INDIANA DEPARTMENT OF TRANSPORTATION
Driving Indiana's Economic Growth

APPROVED MINUTES

December 19, 2013 Standards Committee Meeting

RE: Minutes from the December 19, 2013 Standards Committee Meeting

610-MBAP-01 MAILBOX APPROACHES HIGH SPEED ROADWAY (DRAFT)

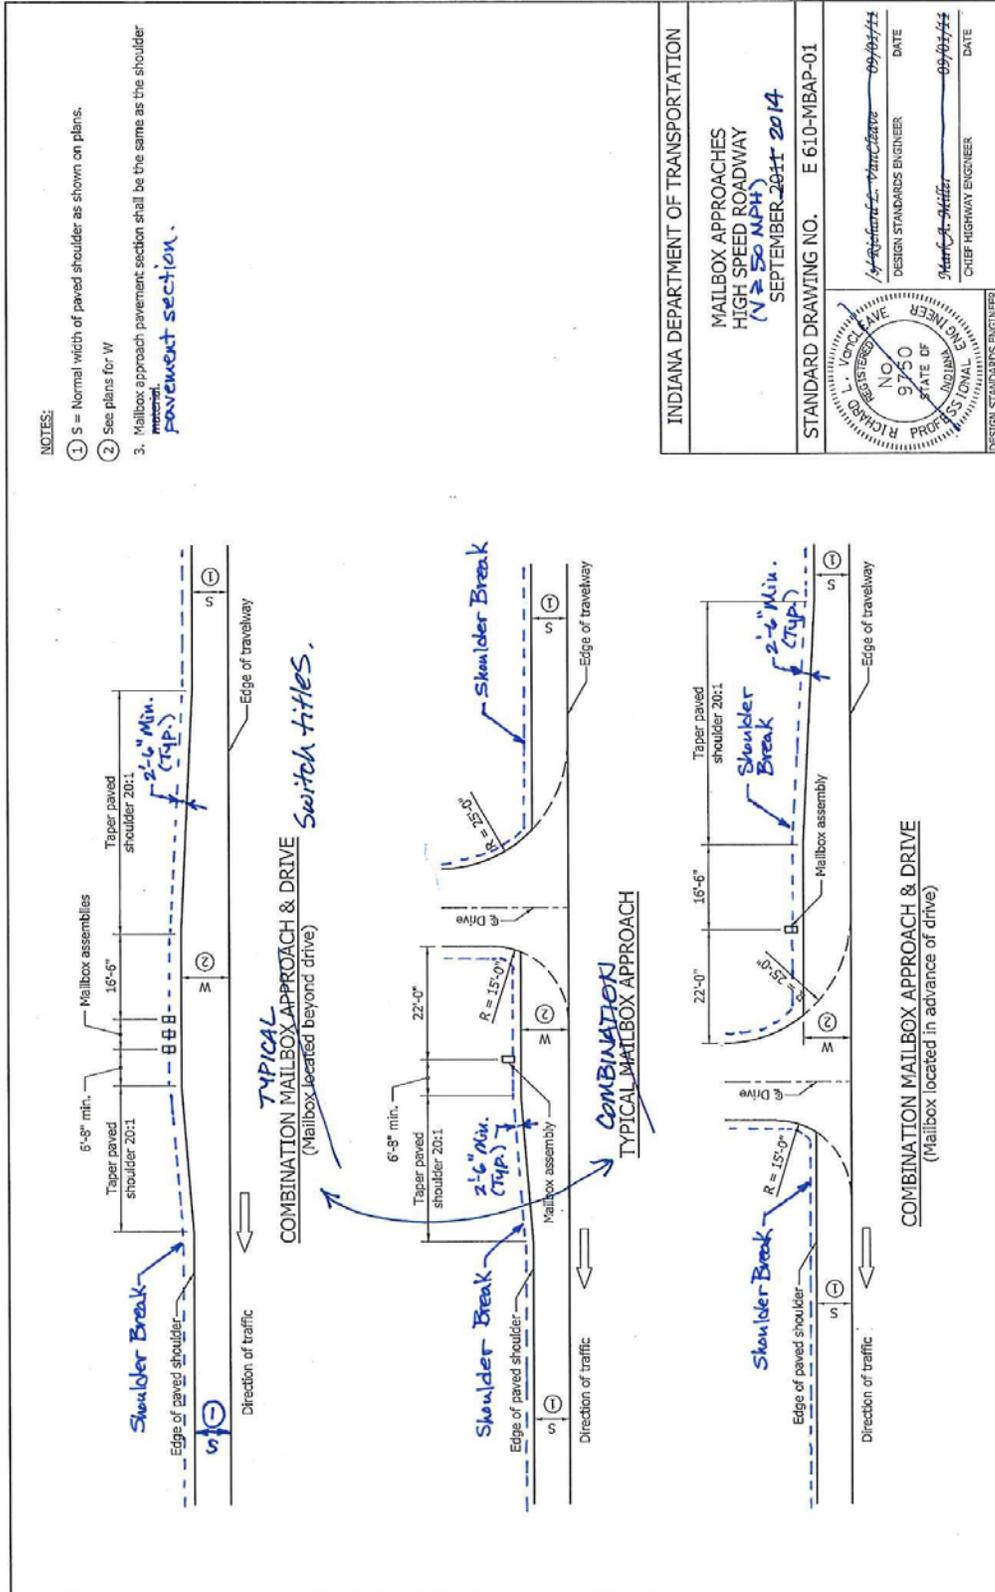
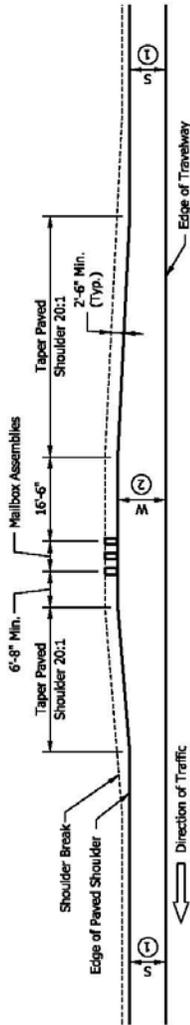
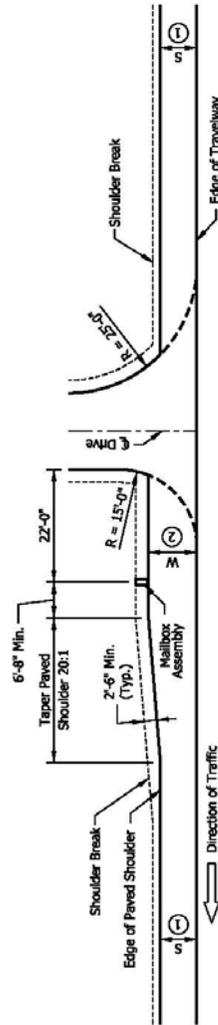
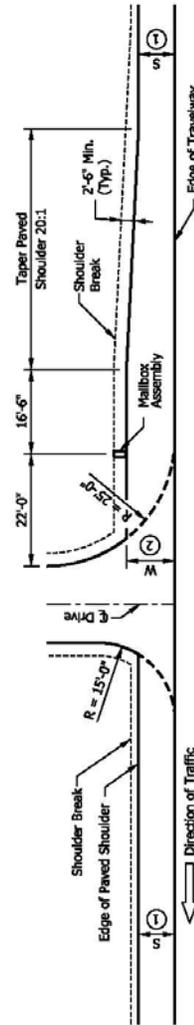
PROBLEM(S) ENCOUNTERED: Issues discovered related to the notes and drawing views on Standard Drawings 610-MBAP-01 and -02.

PROPOSED SOLUTION: See attached markups for proposed editorial revisions to Standard Drawings 610-MBAP-01 and -02. These revisions include correction of language in notes, correction of titles of drawing views (sheet -01), addition of text to drawing titles, update of drawing format and title blocks, addition of shoulder break (sheet -01) and callouts, and rearrangement of drawing views to show typical configuration first.

DISCUSSION: Mr. VanCleave introduced and presented this item explaining that the revisions to the drawings are editorial. The revisions include correction of language in the notes, corrections to the titles of drawing views, updating the drawing format and title blocks, as well as rearranging the drawing views for clarity.

609-RCBA-01 REINFORCED CONCRETE BRIDGE APPROACH SQUARE (REVISED DRAFT)

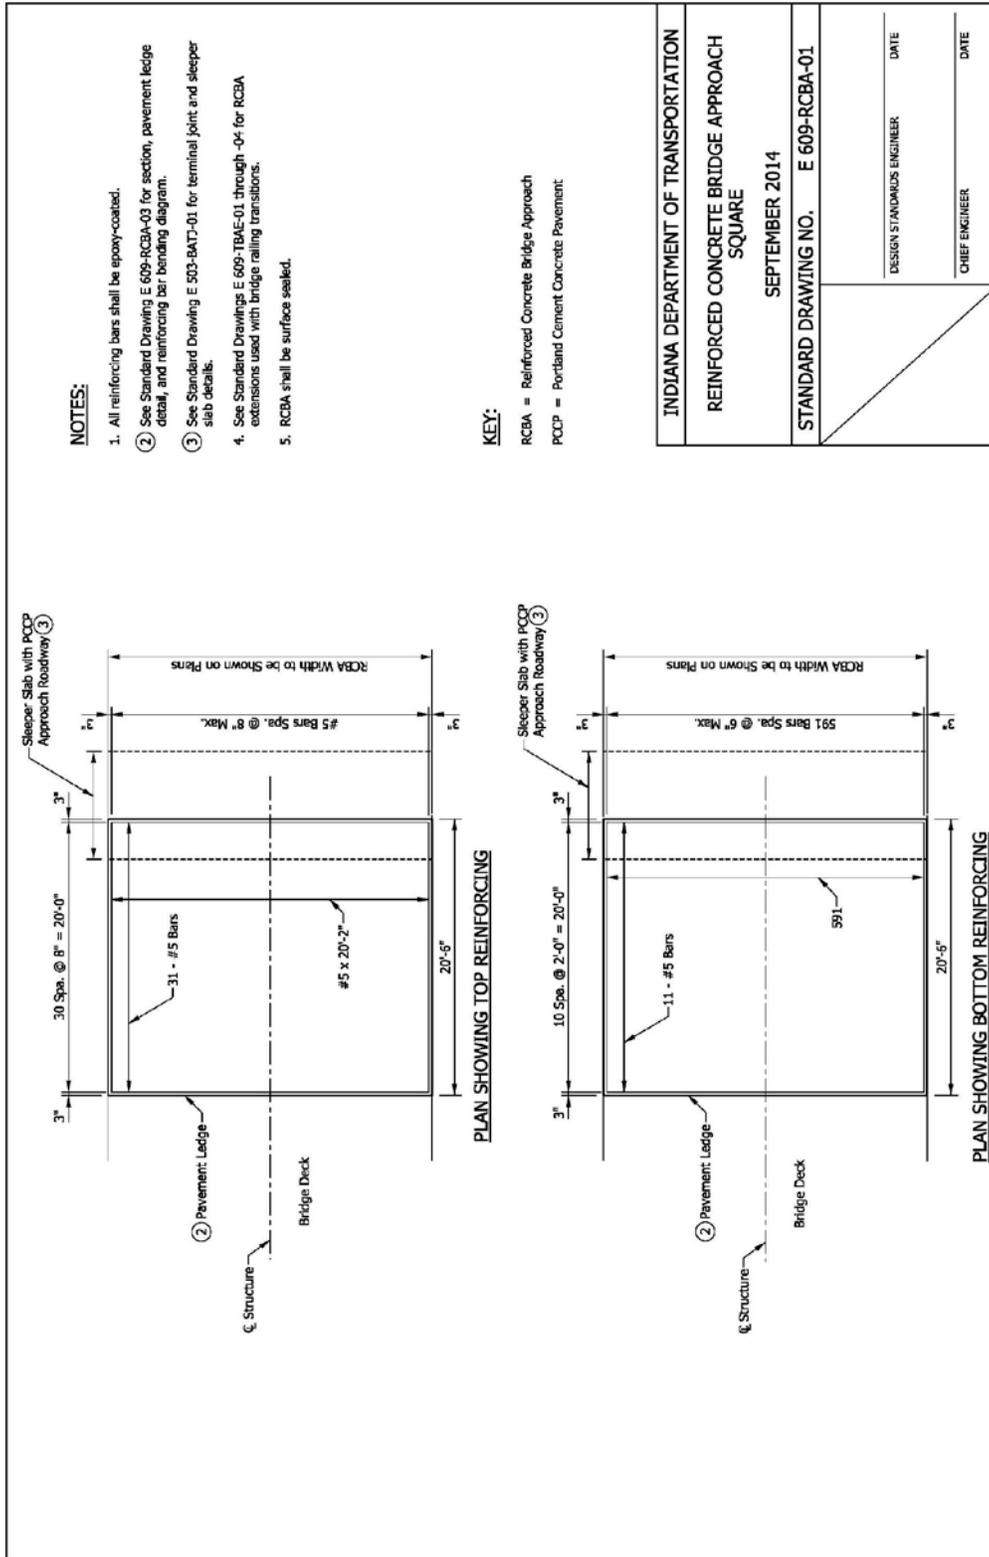
DISCUSSION: Ms. Phillips introduced and presented this item explaining that 609 and the attached standard drawings needed to be revised to include the use of threaded tie bar assemblies. Ms. Phillips addressed the highlights of the revisions presented, indicating the introduction of the threaded tie bars relating to constructability issues.
